**Re: Aloft Hotel Sunport**  
**1501 Aircraft Ave. SE**  
**Traffic Circulation Layout**  
Engineer's Stamp 7/16/2025 (M15D057)

Based upon the information provided in your submittal received 06-30-25, the above referenced plan cannot be approved for Building Permit until the following comments are addressed:

**FIGURE 7.4.117 ADA Accessible Parking Stall and Access Aisle Dimensions**

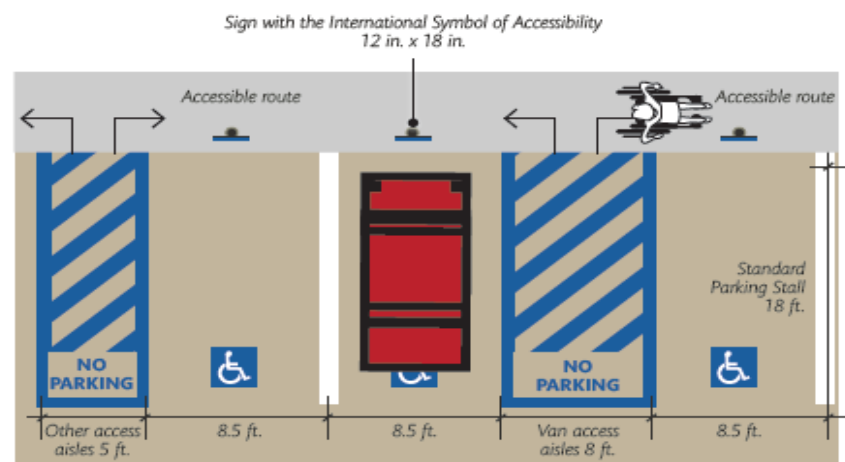
1. Please provide a minimum of 8.5ft with for ADA Accessible Parking.

1. ADA accessible parking shall be a minimum of 8.5 feet wide and 18 feet long. (See [TABLE 7.4.77](#) and [FIGURE 7.4.117](#).)
2. Accessible parking spaces shall be located closest to the building entrances and dispersed among the various types of parking facilities and uses.

3. All accessible parking spaces shall include an access aisle.
4. Van access aisles shall be a minimum 8 feet wide; all others shall be a minimum 5 feet wide.
